**PROJECT # 12074**  
**STORMWATER IMPROVEMENTS**  
**RIVER OAKS NEIGHBORHOOD**  
**PUMP STATION PROPOSED**  
**ELECTRICAL SERVICE PLAN**

BID NO. 12505-613  
RIVER OAKS STORMWATER IMPROVEMENTS  
(P11868)

**ADDENDUM NO. 6**

ISSUED: May 3, 2021

**SHEET NO.**  
**CZ-DT-18**  
**TOTAL:** 254  
**CAD FILE:** 11868-CZ-DT-18.22  
**DRAWING FILE NO.** 4-142-42

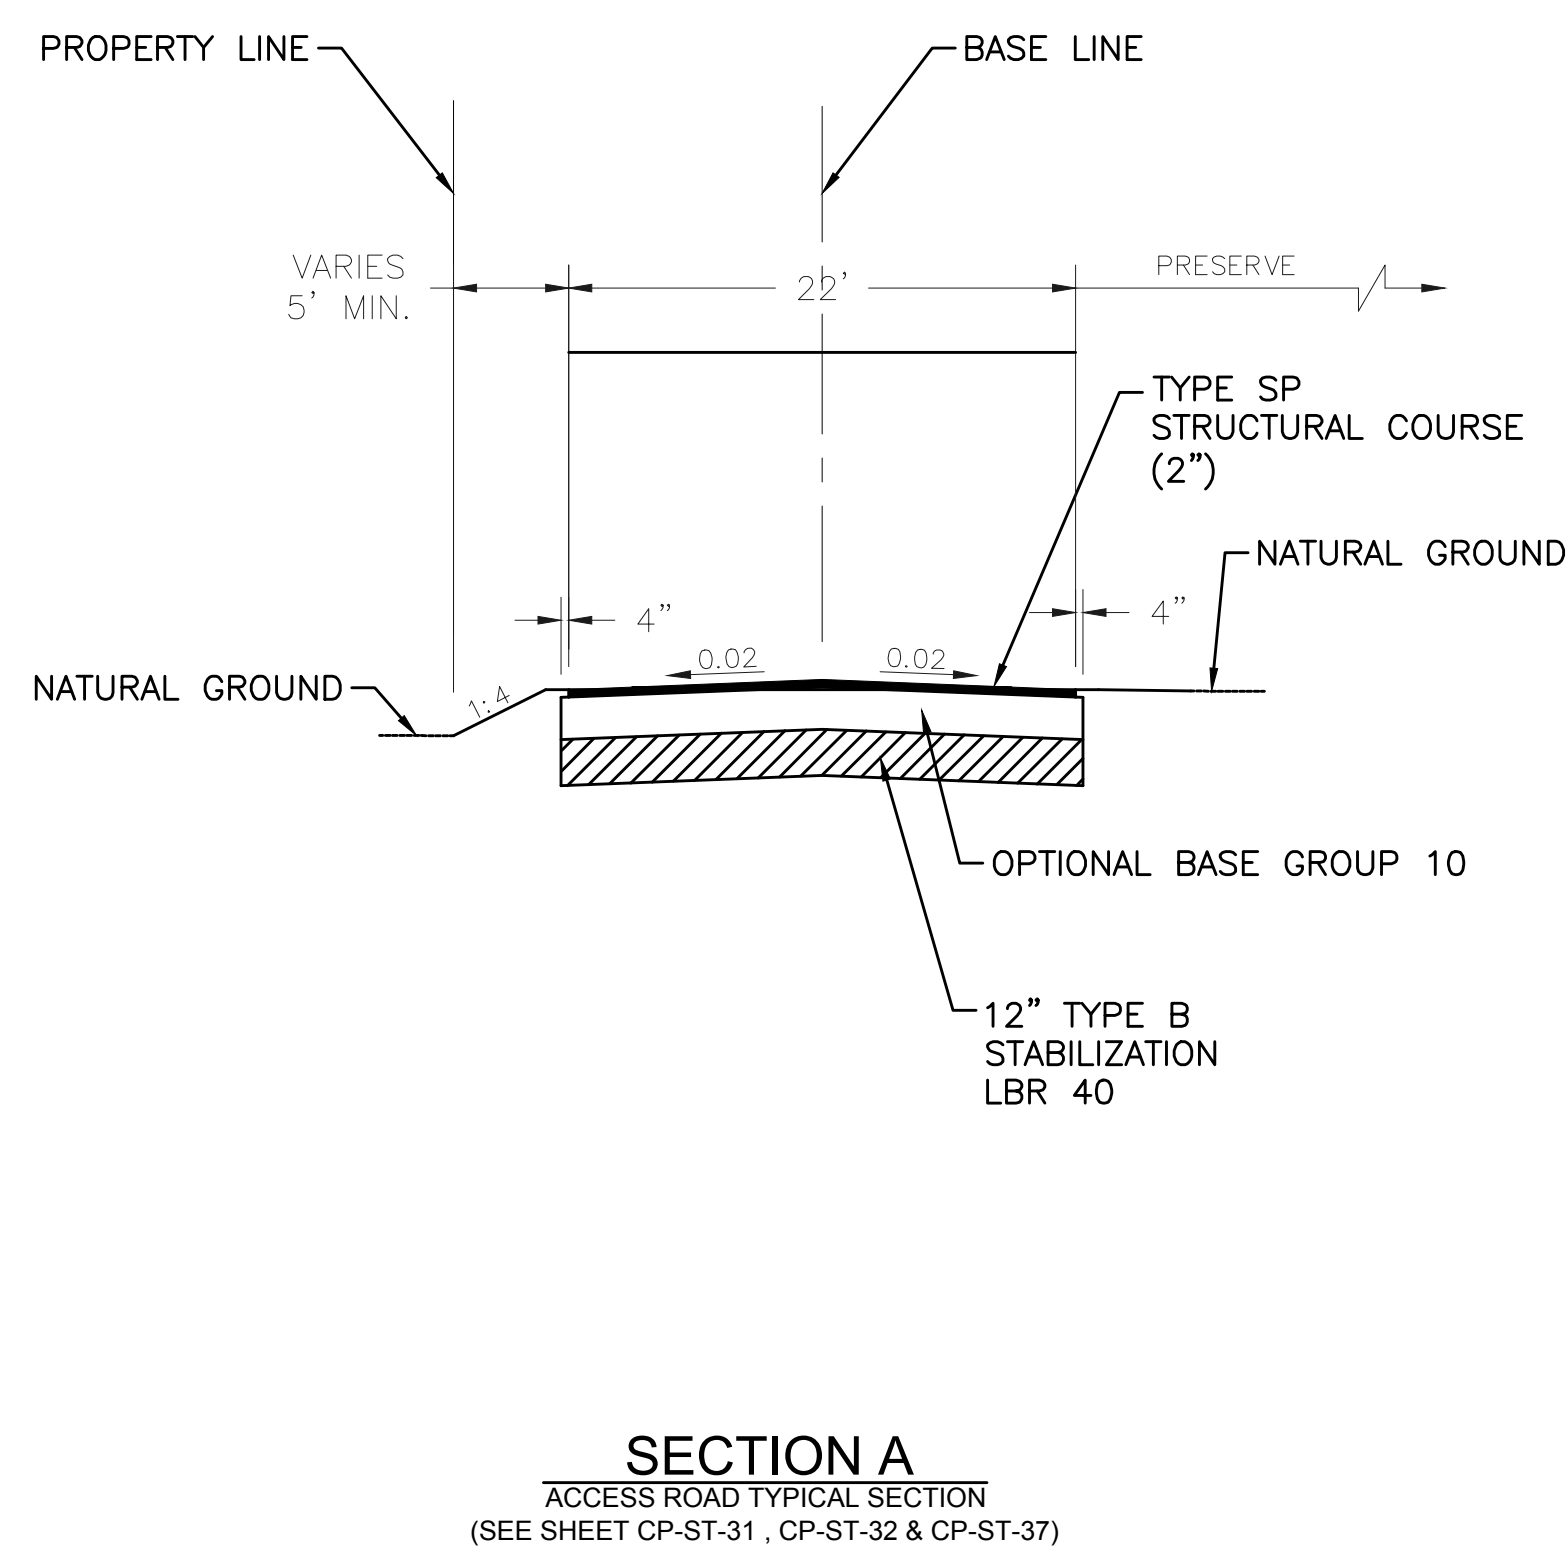
- q. Sheet #CZ-DT-18 – WATER QUALITY CONTROL STRUCTURE DETAILS
  - i. Revised sheet to provide driveway paver detail & header curb detail.
- r. Sheet #CZ-DT-19 – WATER QUALITY CONTROL STRUCTURE DETAILS
  - i. Provided dimensions for diversion bypass vault included with #S378 (Structure now shows inner dimensions of 9'x14')
- s. Sheet #C-03 – WATER MAIN EXTENSION PLAN
  - i. Revised sheet to provide updated proposed 6" DIP water main alignment & connection details, eliminated crossing with proposed 66" RCP.
